SERVICE BULLETIN

SB-AG-60

Revision B 01/20/2015

Environmental Protective Cover for EDC-33

Figure 60-1

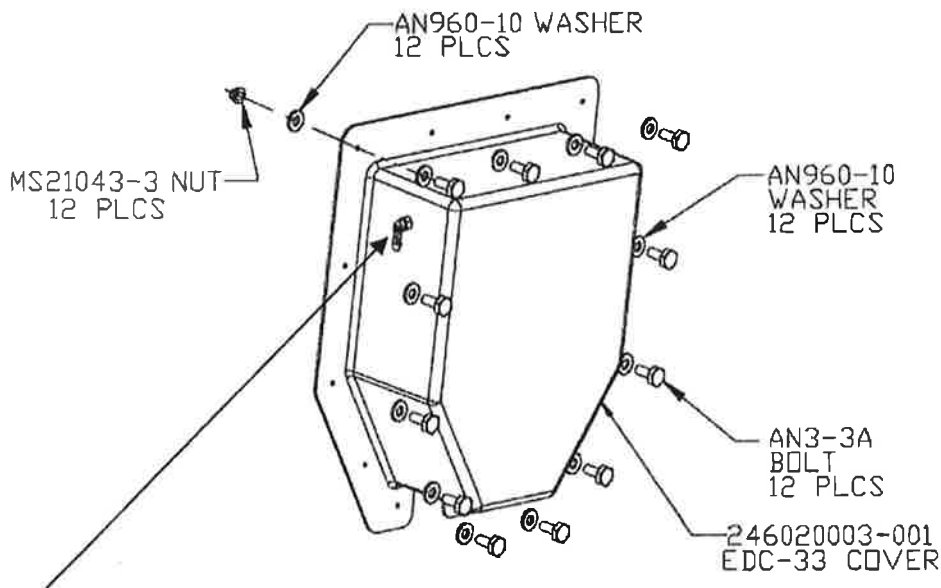
The EDC-33 is just aft of the Battery Plate Assembly mounted on the baggage compartment. See Figure 60-1.

Figure 60-2

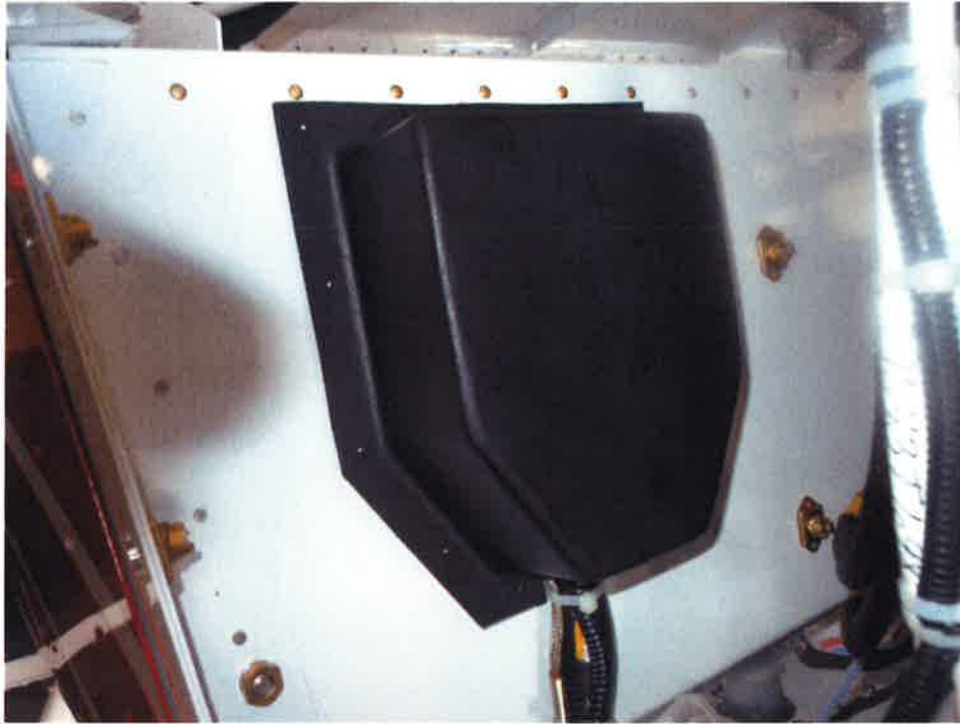
H80 Installation: See Figure 60-2

Assemble Cover Over The EDC 33.

Use The Cover As Drill Template And Match Drill (12) #10 Diameter Holes To Mount The Cover.

Use (12) AN3-3A Bolts And (12) AN960-10 Washers On The Outside Of The Baggage Compartment Shown.

Use (12) AN960-10 Washers And (12) MS21043-3 Nuts And The Inside Of Baggage Compartment To Complete The Installation.

Figure 60-3

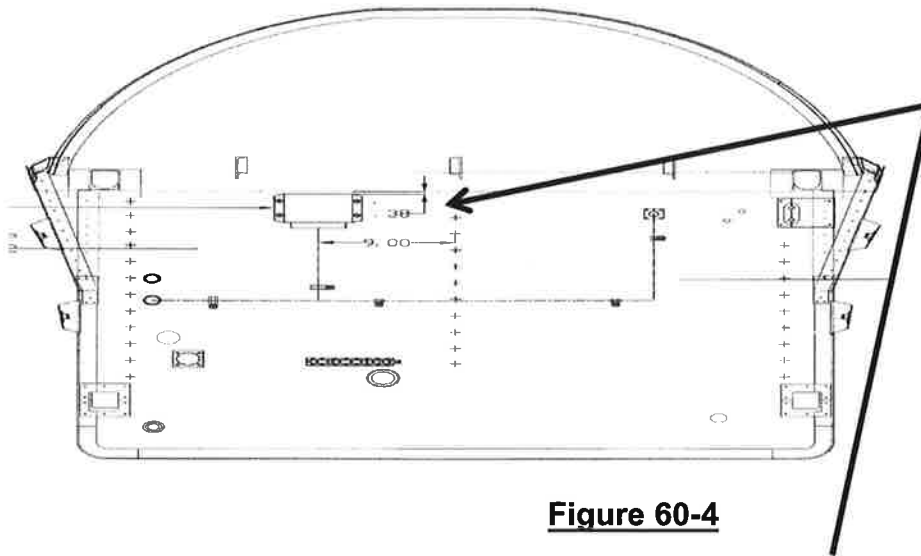
The EDC Is Just Aft Of The Battery Plate Assembly And Is Mounted On The Firewall.
See Figure 60-3.

This unit will have to be Relocated From The Current .38" Dimension Shown above to the new Dimension 1.75" and Remounted to ensure that Cover Does Not Contact the Rivets Above.

Mark New Location For Mounting Holes and Drill 4 Places. Use A #19 Drill.

Plug the Existing Mounting Hold with MS20615-4M3 Rivets
